SUBJECT: Forwards response to NRC questions raised in 870922
 telcon re util ATWS submittal. Issues discussed include
 conceptual design, isolators, uninterruptible power supply &
 frequency of end-to-end testing.

Re: Turkey Point Units 3 and 4
Docket Nos. 50-250 and 50-251
Anticipated Transient Without Scram (ATWS)

TURKEY POINT UNITS 3 & 4
AMSAC CONCEPTUAL DESIGN
LOGIC POWER SUPPLIES
SIMPLIFIED ONE LINE DIAGRAM
FLORIDA POWER & LIGHT COMPANY
DATE
SCALE

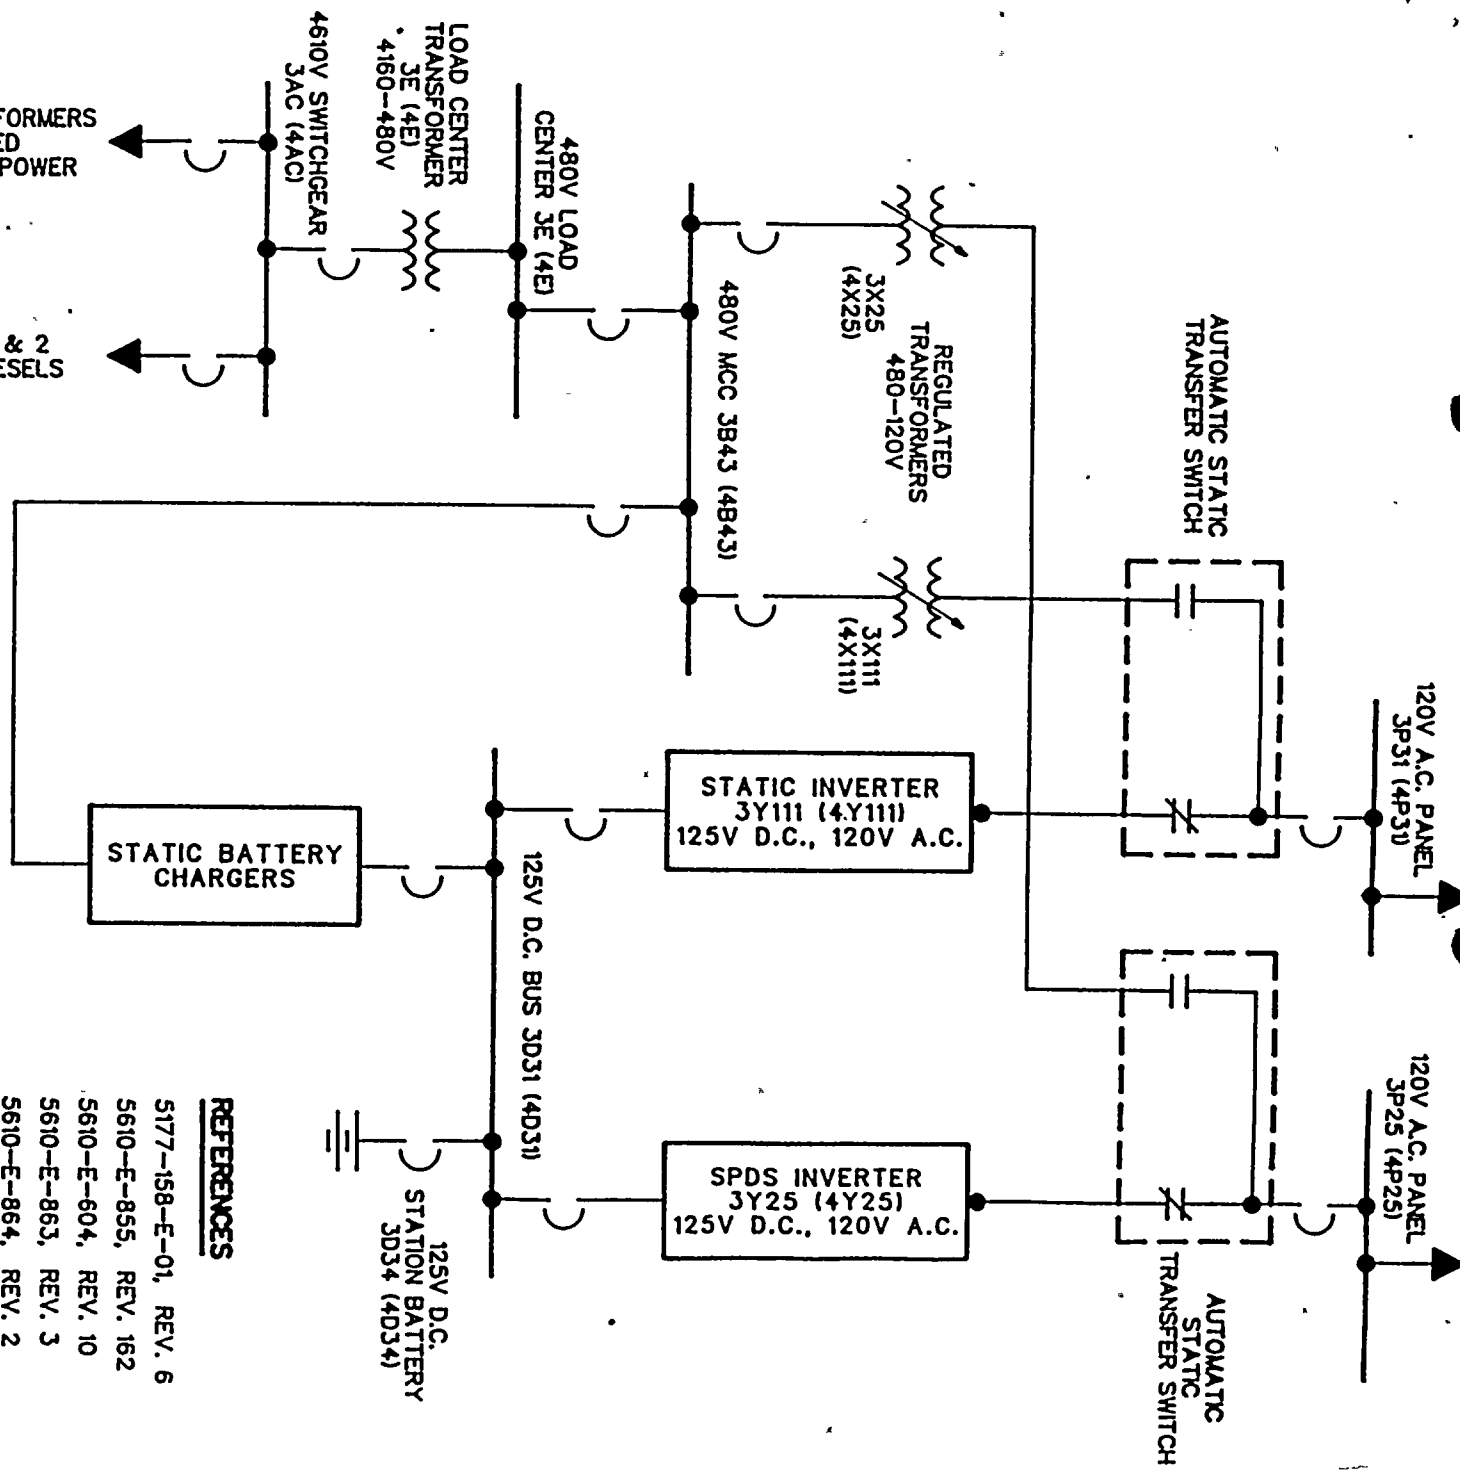
QUESTION 3: What is meant by an "uninterruptable" power supply?

The power sources specified for AMSAC, 3P25, 4P25, 3P31 and 4P31 are considered uninterruptable because the power feeds are normally from battery backed static inverters and automatically transfer on loss of the normal power feed to an alternate AC supply. This arrangement allows for a continuous power supply in case of a loss of offsite power or failure of a single piece of equipment. A simplified one line diagram for the power supplies is shown in the Attachment.
